Addendum 3
TFM-029-26 – TA-511-25 ACADEMIC TUNNELS RE-WATERPROOFING CP-1

- .2 The Date of the Addendum is Friday, May 01, 2026

ACADEMIC TUNNELS RE-WATERPROOFING

TA-511-25

DESIGNED: S.C	DRAWN: S.C
REVIEWED: H.H/C.B	APPROVED: H.H/C.B
SCALE: AS SHOWN	DATE: APRIL, 2026
PROJECT No. TA-511-25	DRAWING No. C-2.9

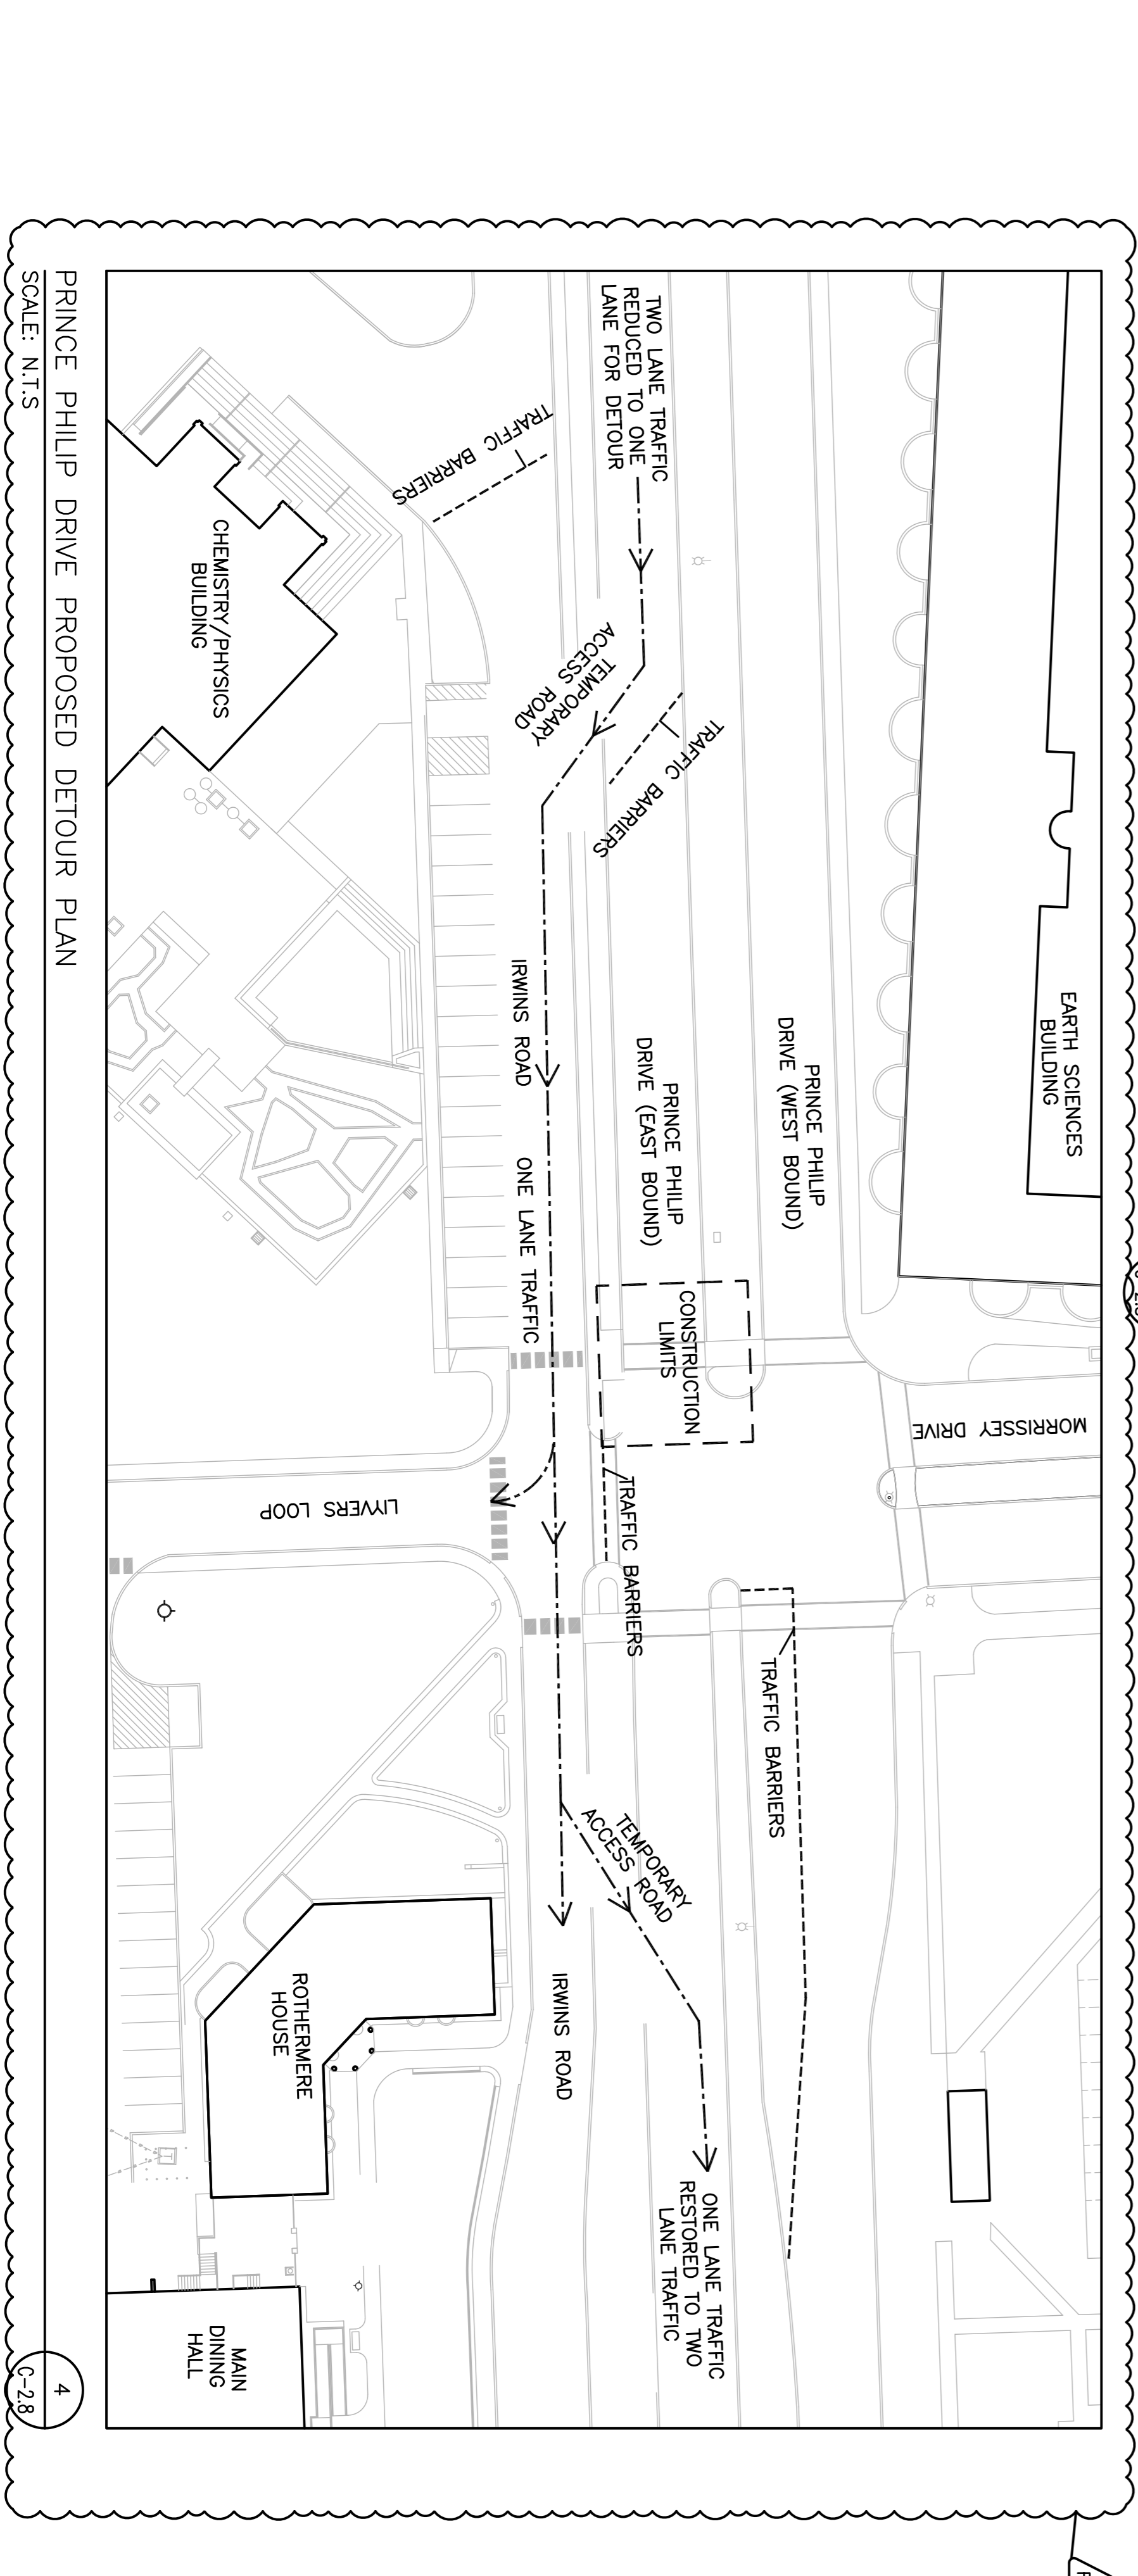
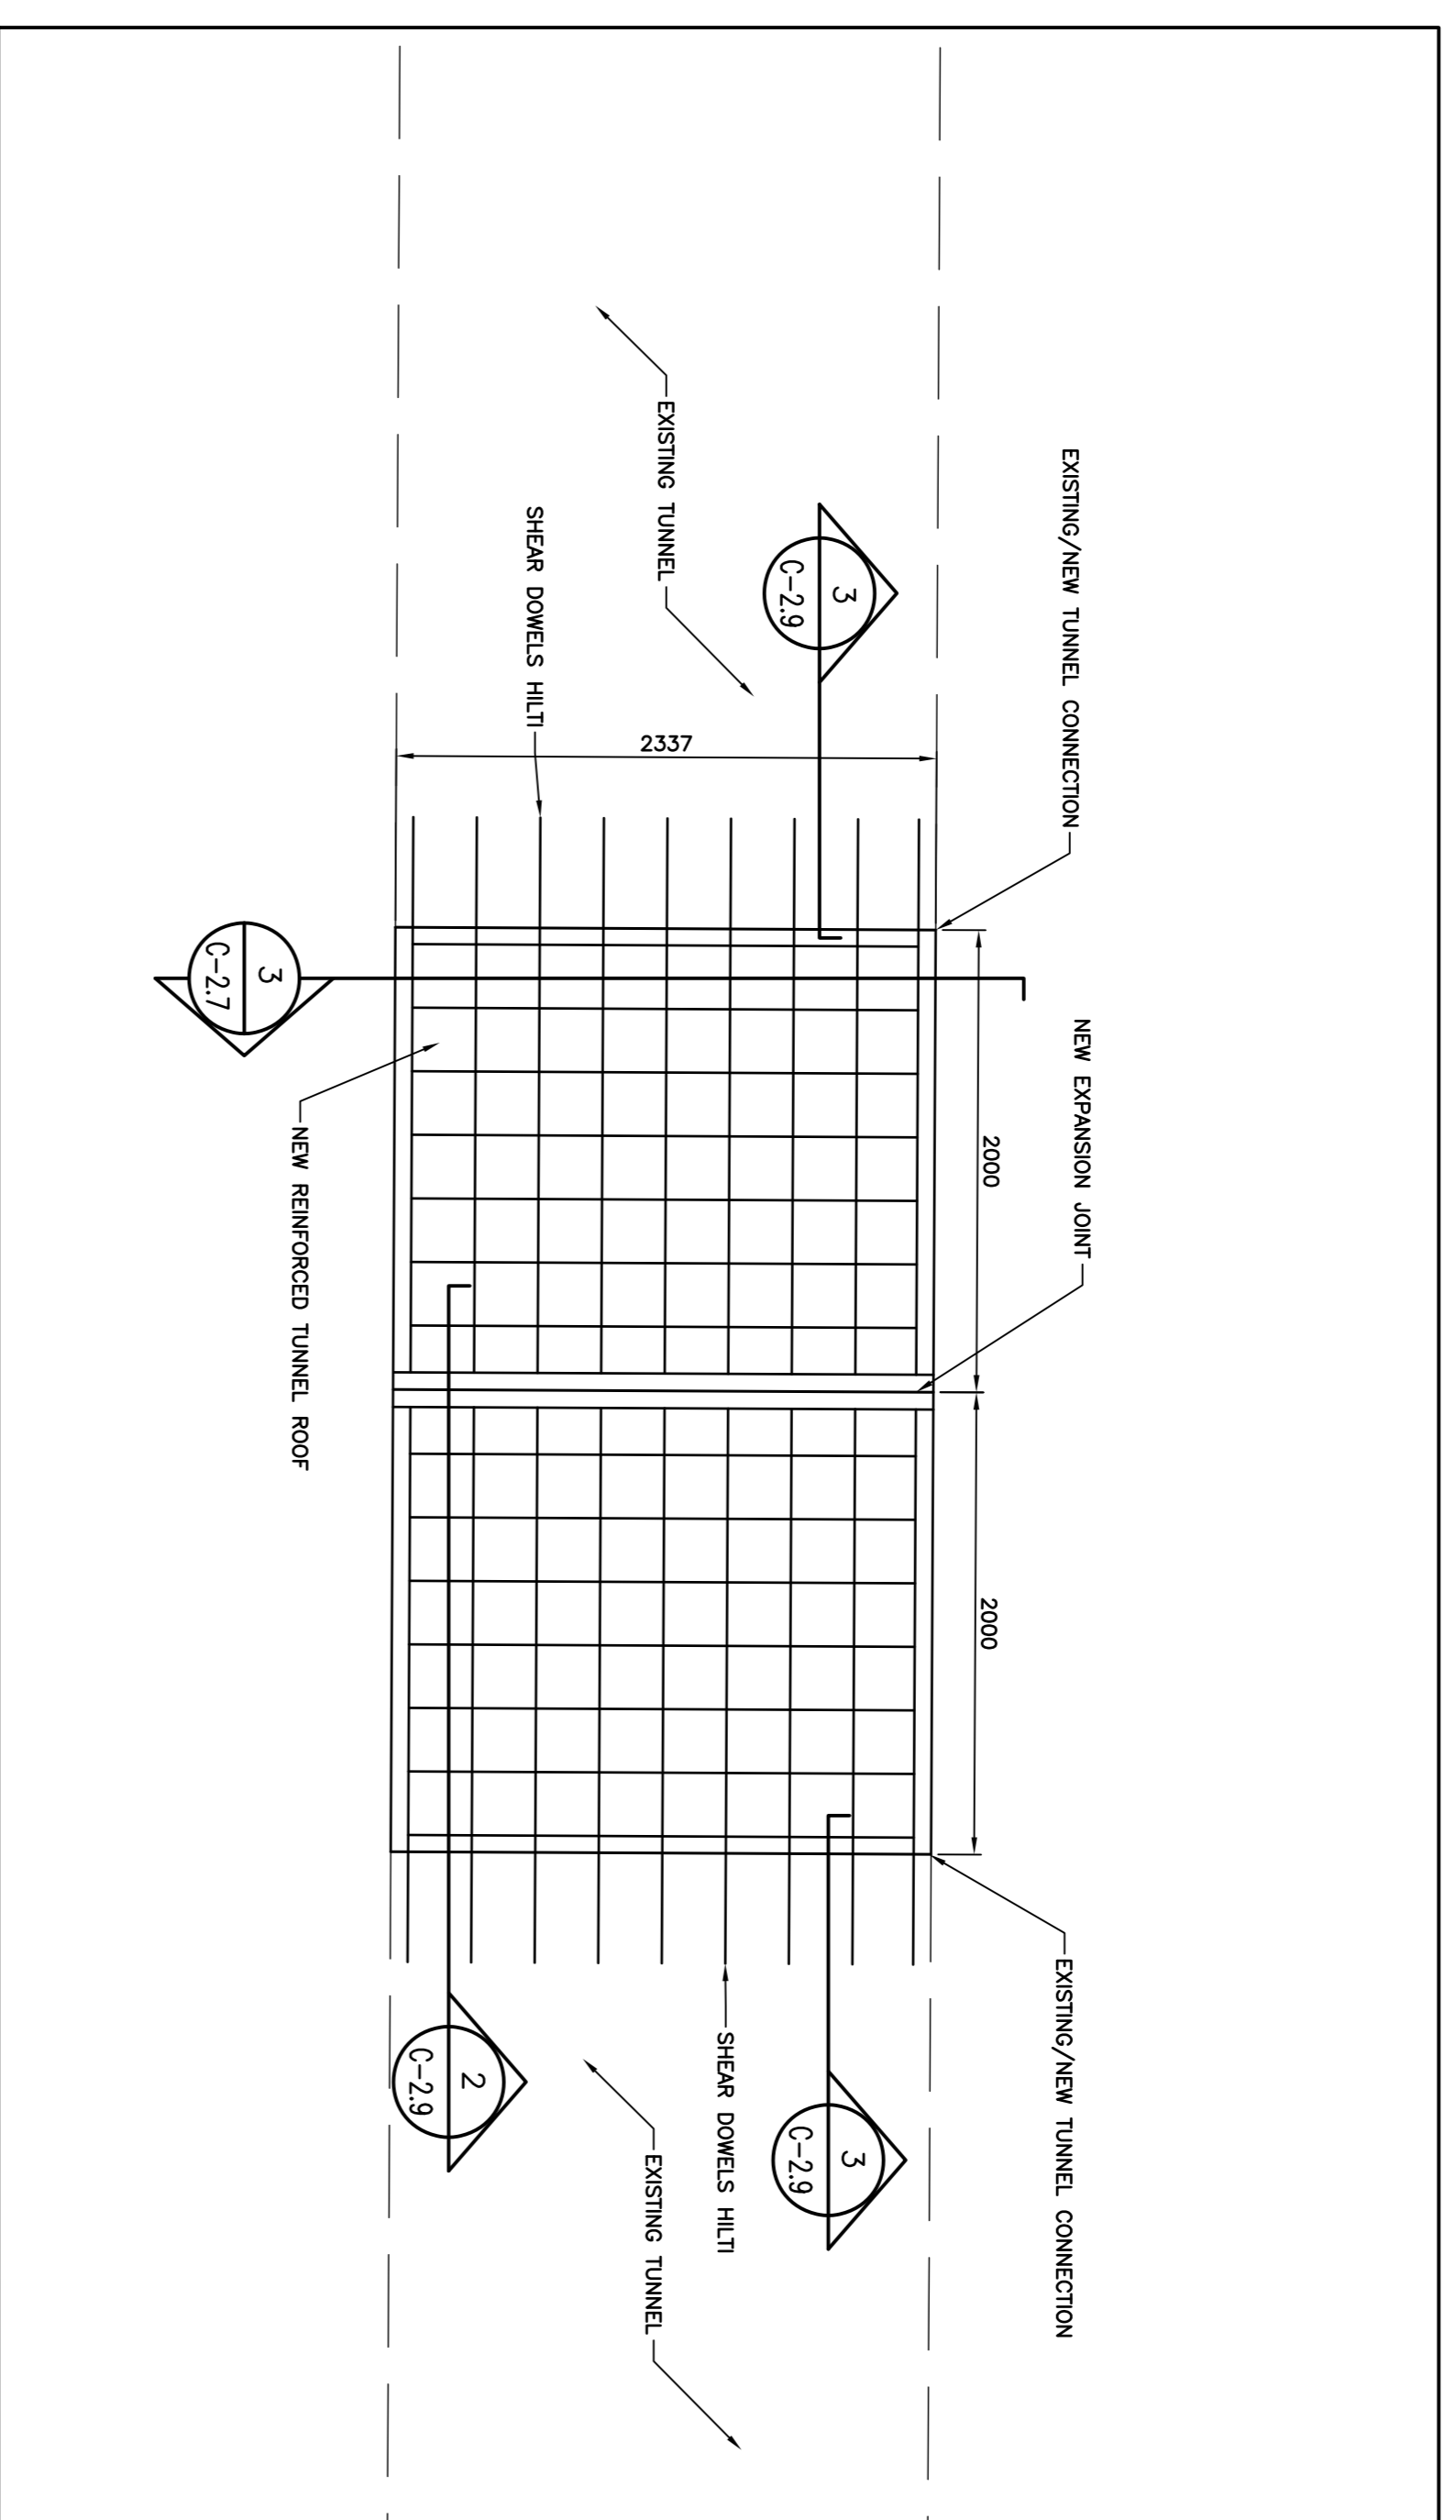
1. **Replace** drawing Cover Page (attached).
2. **Replace** drawing C-1.0 R3 with C-1.0 R4 (attached)
3. **Replace** drawing C-1.4 R0 with C-1.4 R1 (attached)
4. **Replace** drawing C-2.7 R0 with C-2.7 R1 (attached)
5. **Replace** drawing C-2.8 R0 with C-2.8 R1 (attached)
6. **Add** drawing C-2.9 R0 (attached)
